Product Change Notice (PCN)

PCN Number: PCN-0451198R-01

Product(s) Affected: PJ-054

PREVIOUS CUI DEVICES DETAIL / IMAGE	NEW CUI DEVICES DETAIL / IMAGE

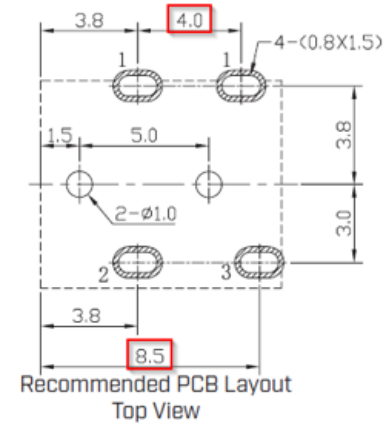
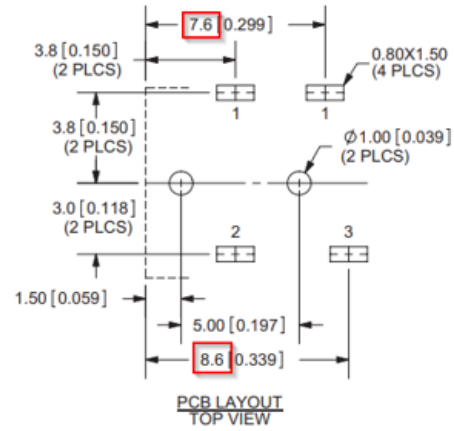
Description of Change: Mechanical, material, and PCB layout changes as noted below.

MATERIAL	PLATING
center pin	brass	nickel
terminal 1	brass	tin
terminal 2	copper alloy	tin
terminal 3	brass	tin
plastic	PA66

DESCRIPTION	MATERIAL	PLATING/COLOR
center pin	H65 brass	nickel
terminal 1	brass	silver
terminal 2	bronze	silver
terminal 3	brass	silver
housing	PA9T (UL94V-0)	black

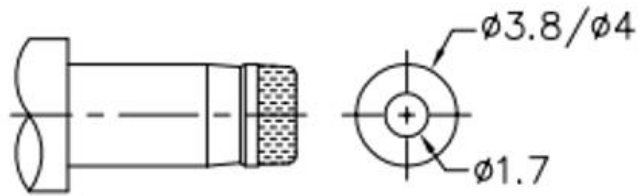
MATING PLUG
Jack Insertion Depth: **6.2 mm**

MATING PLUG
Jack Insertion Depth: **6.1 mm**
